# UNITED STATES PATENT AND TRADEMARK OFFICE

10/797,565

<b>Office Action Summary</b>	<b>Application No.</b> 10/797,565	<b>Applicant(s)</b> GRIFFITHS, STEVEN M.	
	<b>Examiner</b> ELIZABETH R. MACNEILL	<b>Art Unit</b> 3767

## DETAILED ACTION

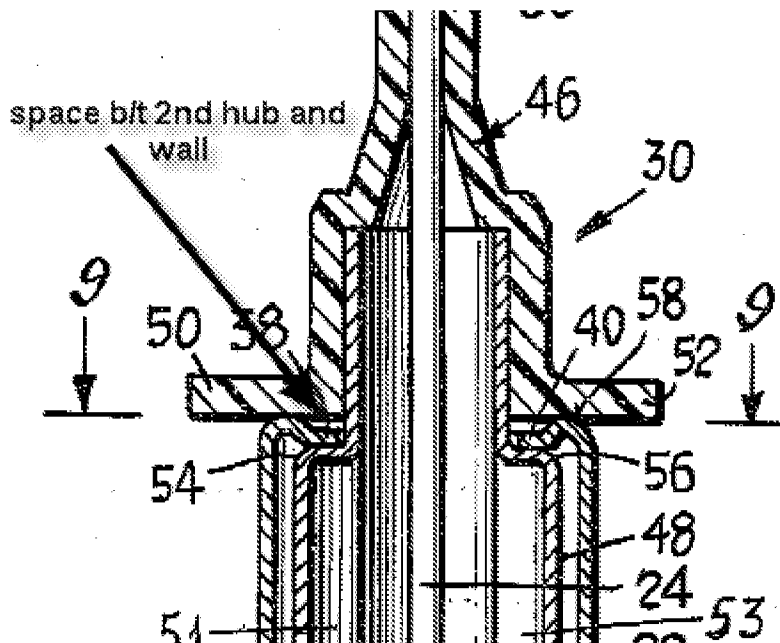
As to claims 1 and 16, Kruck does not teach that the 1<sup>st</sup> hub, 2<sup>nd</sup> hub, and wall are sandwiched together. Kruck seems to show a space between the 2<sup>nd</sup> hub and the wall (portion of Fig 1 labeled below):

Kruck teaches that “The fully locked position is defined by engagement of the flanges 50, 52 of the cup portion 46 with the upper surface 58 of the ferrule, and by engagement of the hub shoulders 54, 56 with the inclined shoulders 38, 40 of the ferrule.” See Fig 3, which shows that on upper wall 58, there is an inclined groove extending partway around the wall (see also Fig 2). It is the examiner's position that the cross-section shown in Fig 1, which shows the gap, is taken at a low point in the inclined groove, and that at another point along the wall, the wall will be flush with the 2nd hub at 50/52. Furthermore, Kruck does not teach any reason for having a gap or why this gap is important to the function of his invention. It would have been obvious to one of ordinary skill in the art at the time the invention was made to flatten top 58 so

that a sandwich is formed from 1st hub to wall 2nd hub to further reinforce the wall portion.
